PLANNING AND ZONING CASE CHECKLIST

Project Number: SP2019-024
Project Name: Friendship Baptist Church
Project Type: SITE PLAN
Applicant Name: [APPLICANT]
Owner Name: ATHEY, BOBBY FRANK
Project Description:

Type of Review / Notes	Contact	Sent	Due	Received	Elapsed Status	Remarks
SP2019-024 Site Plan for Friendship Baptist Church: Please address the following comments (M= Mandatory Comments; I = Informational Comments)

TO: Planning and Zoning Commission
DATE: August 13, 2019
APPLICANT: Shannon Thomas; *Friendship Baptist Church*
CASE NUMBER: SP2019-024; *Site Plan for House of Worship*

4 SOUTH ELEVATION
A3.1 SCALE: 3/32" = 1'-0"

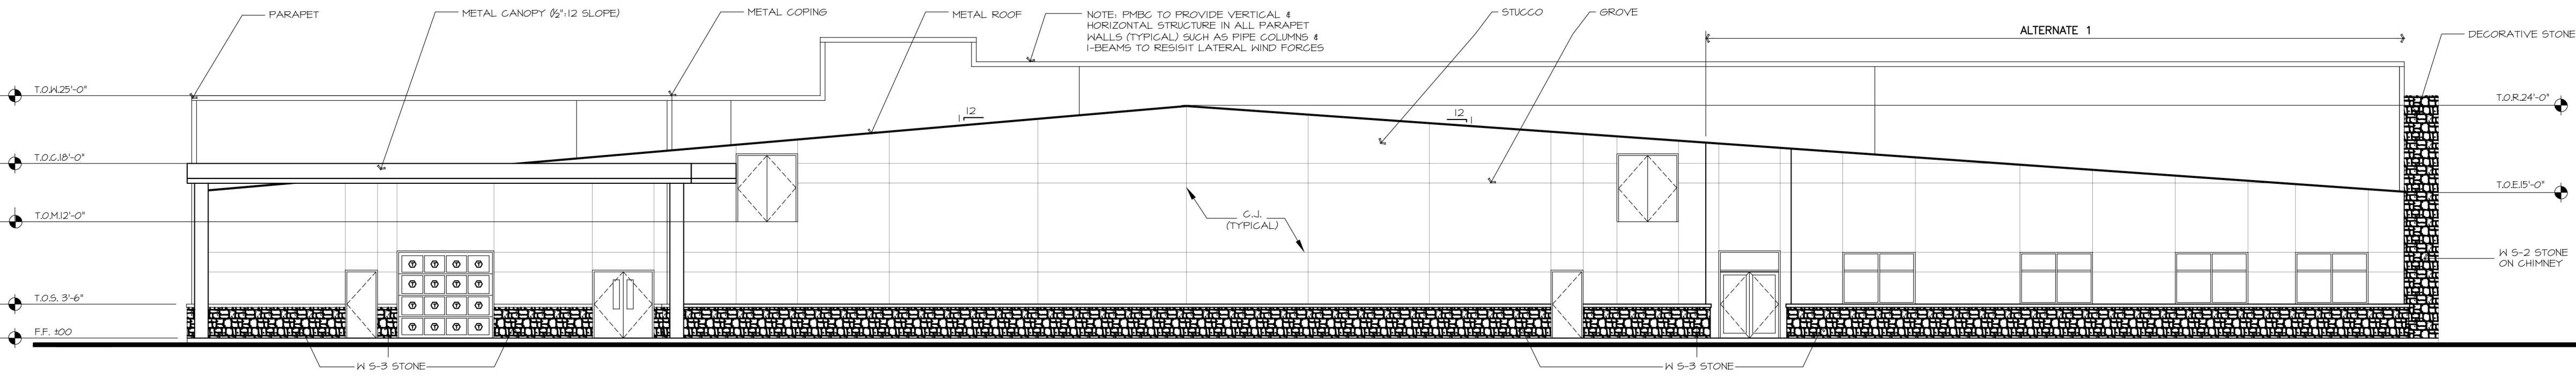
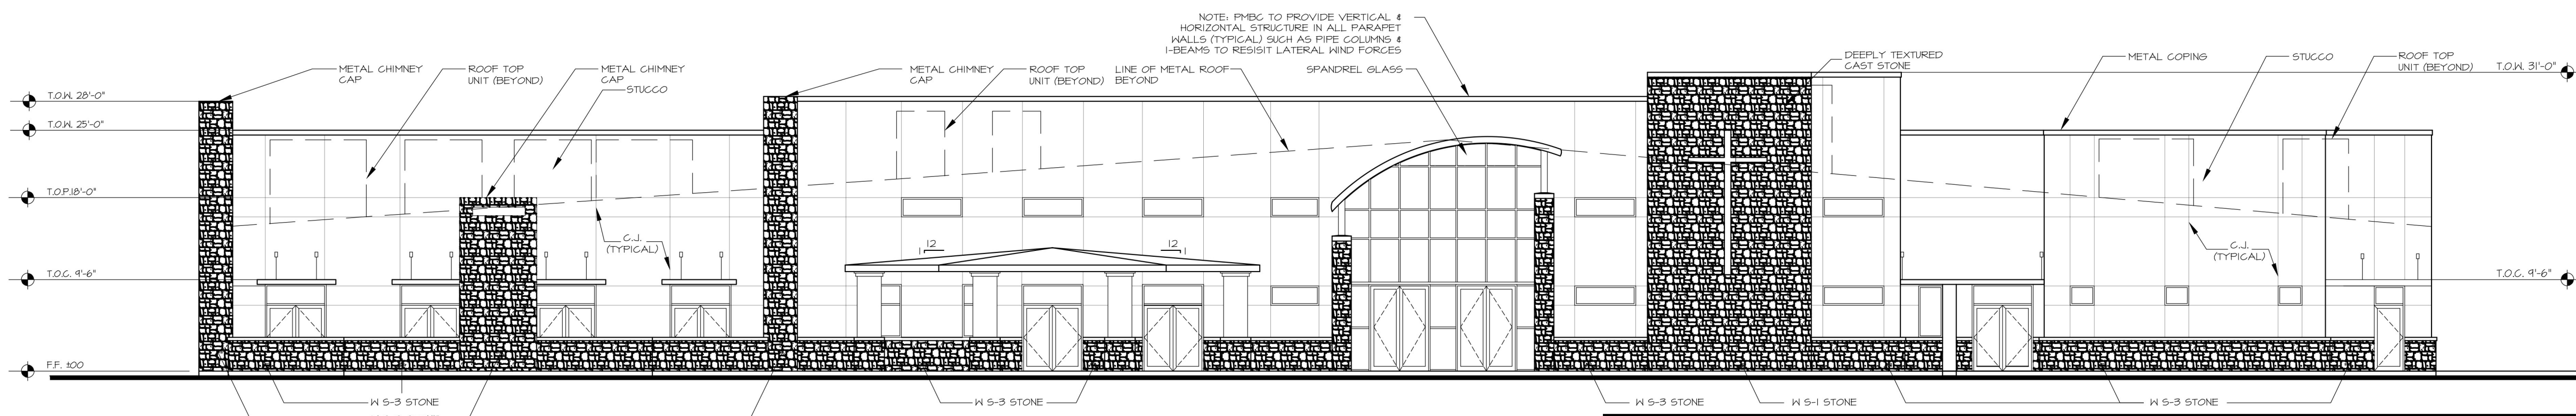
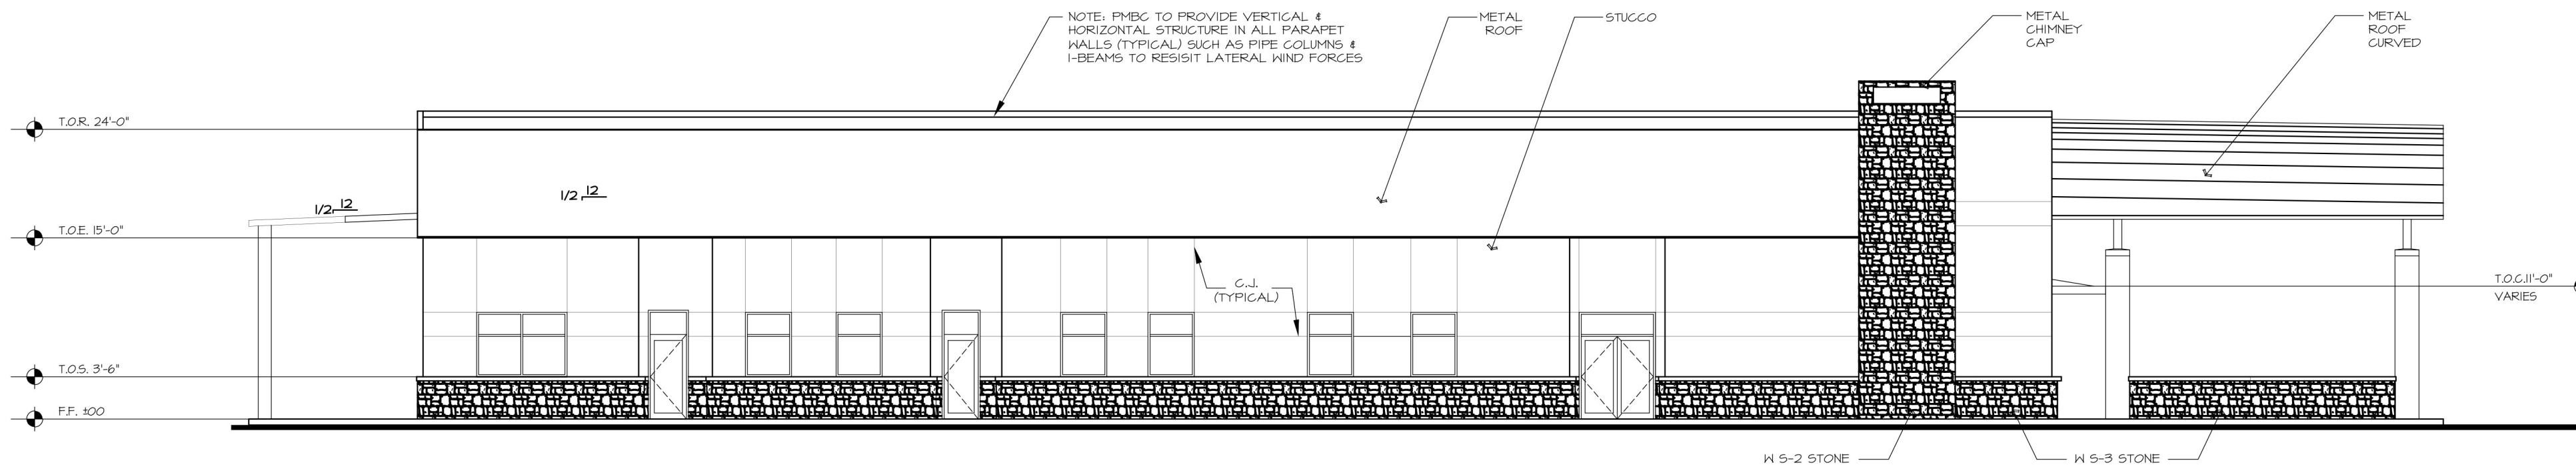
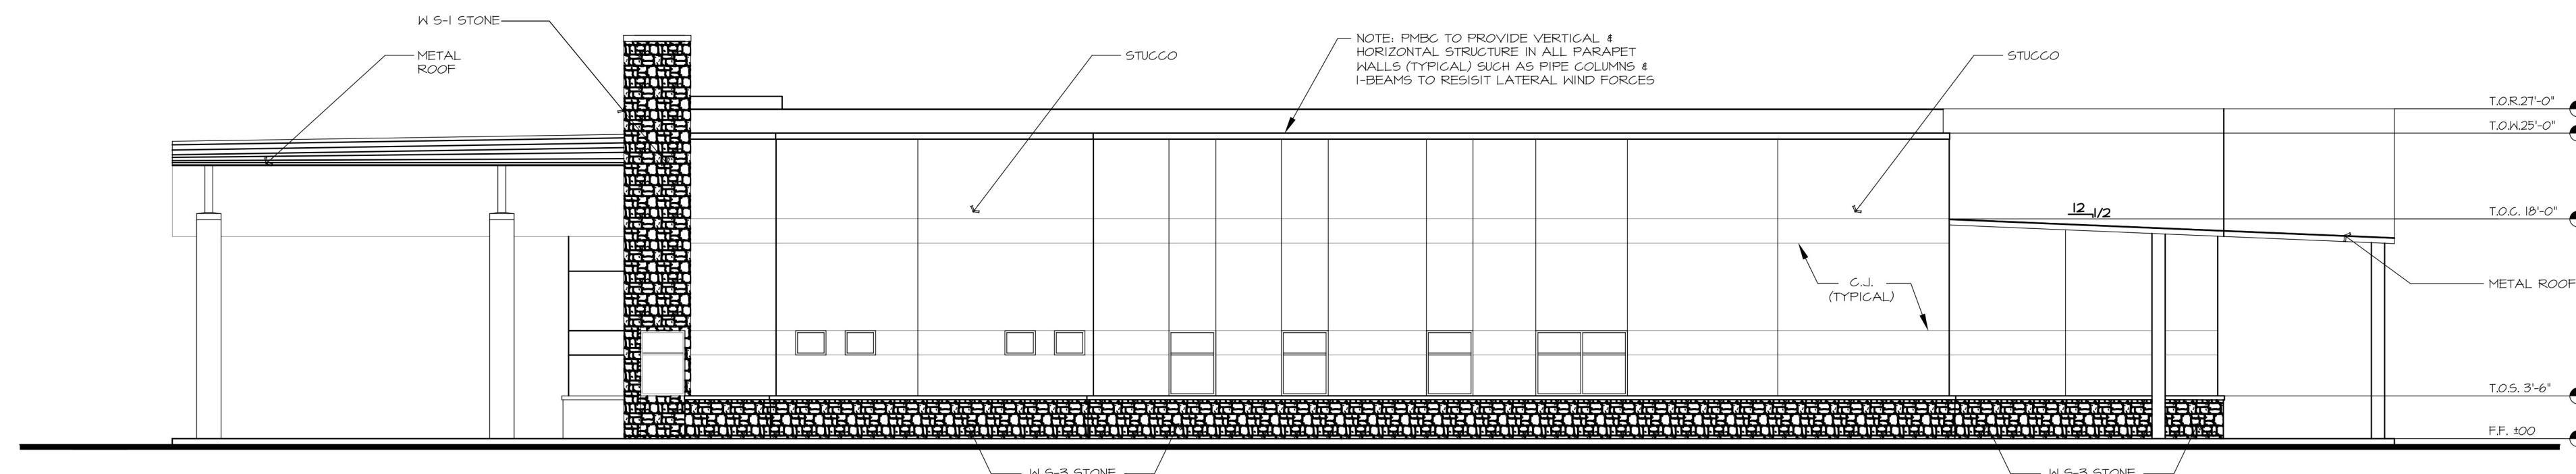
21.						Landscape Plan—Please note, the dumpster cannot face the street.
22.						Please Provide a photometric plan.
23.						Building Elevations—Please note, the John King Overlay requires 4-sided architecture. The rear of the building will have to have a parapet.

24.						Building Elevations—Please show rooftop equipment and how it will be screen on all elevations.
25.						Building Elevations—Please provide a different hatch for each building material being utilized.

26.						Building Elevations—Please do not include windows and doors in your calculations or materials tables.
27.						Building Materials—It would be helpful to have renderings from the rear of the building. It is difficult to understand the elevations. For instance, on the east elevation, there is a parapet, however, on the west elevation, there is a metal roof. Additionally, there is a show wall on the lefthand side of the north elevation, however, it blends with the building and makes it appear that the doors are cut off.

28.						Building Elevations—Please provide shadows to help show projections and recesses on the building.
29.						Building Elevations—The west elevation does not appear to show the projecting element with the pitched roof.

On June 25, 2019, the Architectural Review Board (ARB) reviewed the proposed building elevations and requested that the applicant provide the following: A parapet wall on all four (4) sides of the building; meet the four (4)-sided architecture requirements; raise the stone wainscot to the top of the windows, to provide an alternative color rendering; and, to provide material samples. The applicant has submitted revised building elevations that appear to be generally conforming. The Architectural Review Board (ARB) will review the revised building elevations and forward a recommendation to the Planning and Zoning Commission at the meeting on August 13, 2019.
